TECHNICAL BULLETIN TECH-11-2022

PSA 1.2L – 870248-5002S TURBOCHARGER REPLACEMENT

NOVEMBER 2022

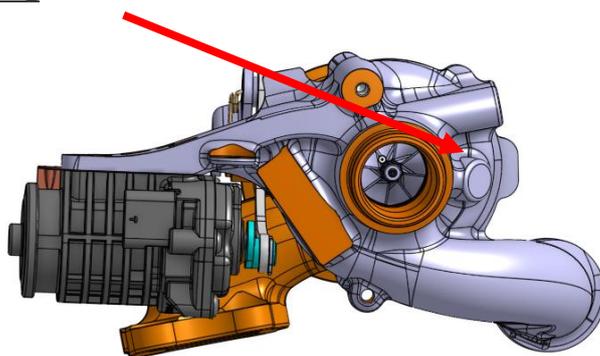
Please note that this Tech bulletin is to inform you of a mistake that was recently made in our online catalogue in specifying the wrong turbocharger PN 901680-5002S as replacement of turbochargers PN 887157-5001S & PN 870248-5002S, which is not a direct service replacement for the following reason explain below.

- TC 901680-5002S is a standalone turbocharger as it doesn't use the e-RCV valve on the compressor housing.

- The correct direct service replacement is as follow: TC PN 870248-5002S replaced by TC PN 887157-5001S as they are using the same e-RCV.
